PLANNER'S REPORT

DATE: January 10, 2019

TO: Tonya Hutson
FROM: Lynn M. Patterson
Posign Review - 903 Margaret Street

The City of Hapeville has received a Design Review Application from Shannon Short requesting new construction of a two-story, 2,475 SF 4 bedroom, 4.5 bathroom single family dwelling with a 404.75 SF detached garage located at 903 Margaret Street. A new driveway would extend along the eastern property boundary from Walnut Street to the garage.

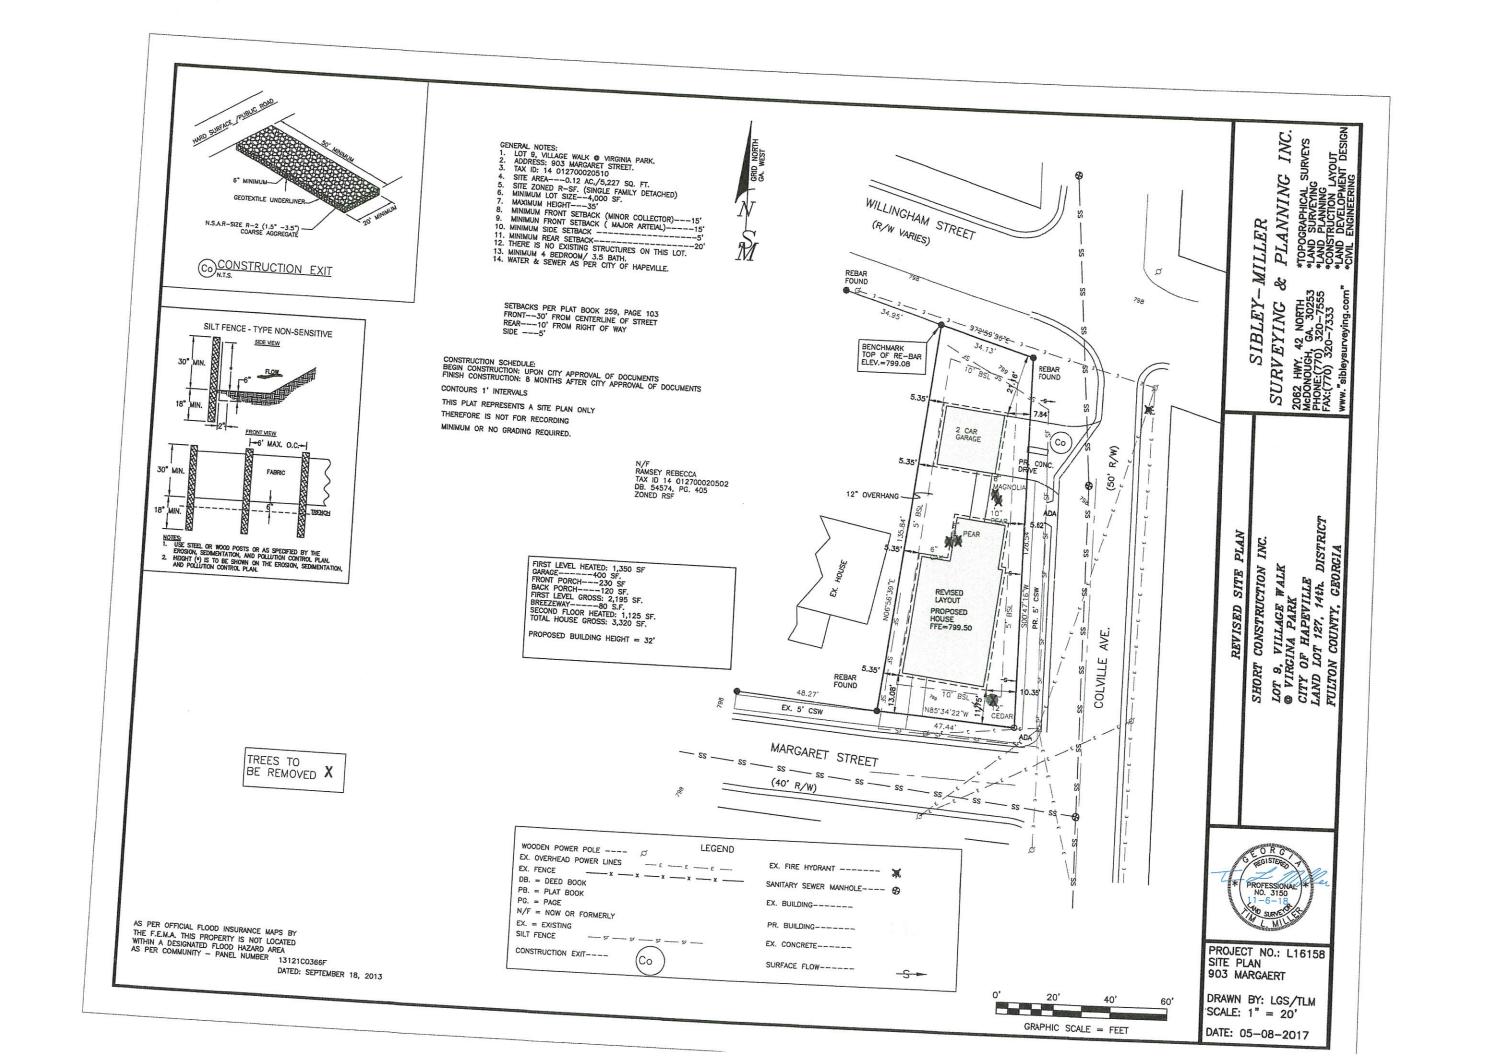
STAFF COMMENT: Driveway is 20' wide to accommodate corner lot. Design exception is required.

Driveway is 20' wide to accommodate corner lot. Design exception is required.

- 1. The house is a slab on grade so the entrance will not be between 2' and 4' above grade. We are installing a brick water table around the base of the home to give it a similar look to homes built on crawl spaces.
- 2. The proposed driveway width is 20' wide instead of 15'. This is because the garage is 20' wide and very close to the road because of the lot size so we need it to be 20' wide to hold 2 vehicles in the driveway

FRONT EXTERIOR ELEVATION

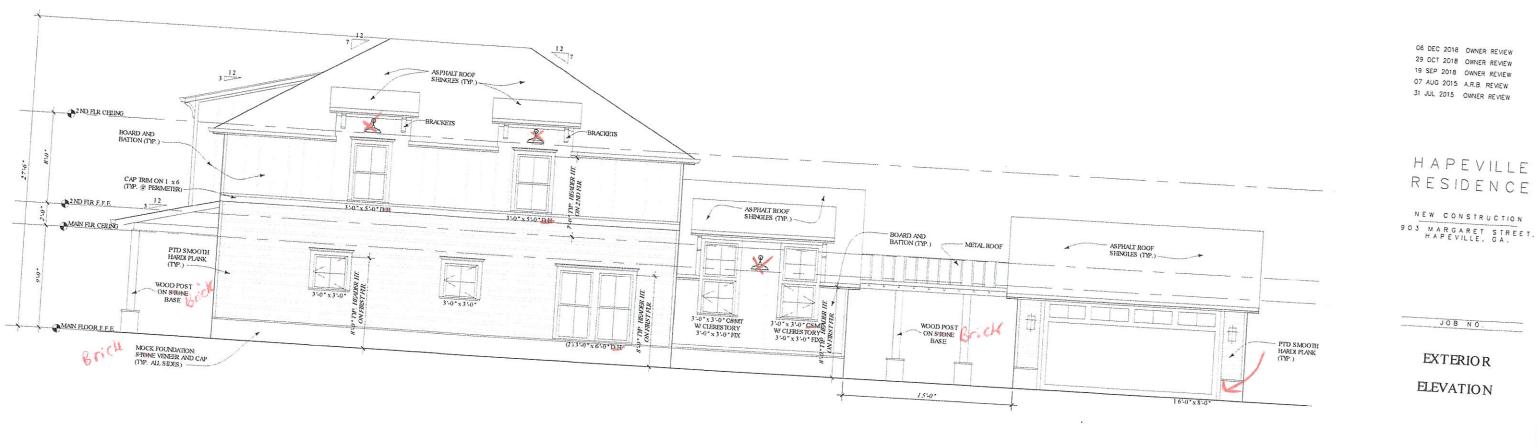
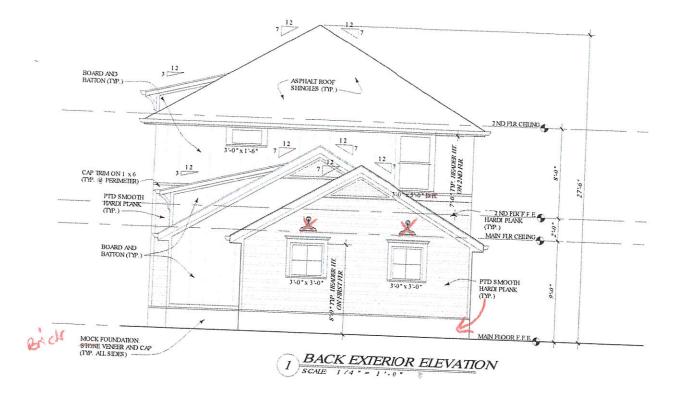
STAFF COMMENT: House is built on slab at grade.

Sill dimension from finished floor elevation should be provided.

House is built on slab at grade. Design exception is required.

Sill dimension from finished floor elevation should be provided.

Sill material should be specified.

Building numbers should be provided.

Porch finishes should be provided.
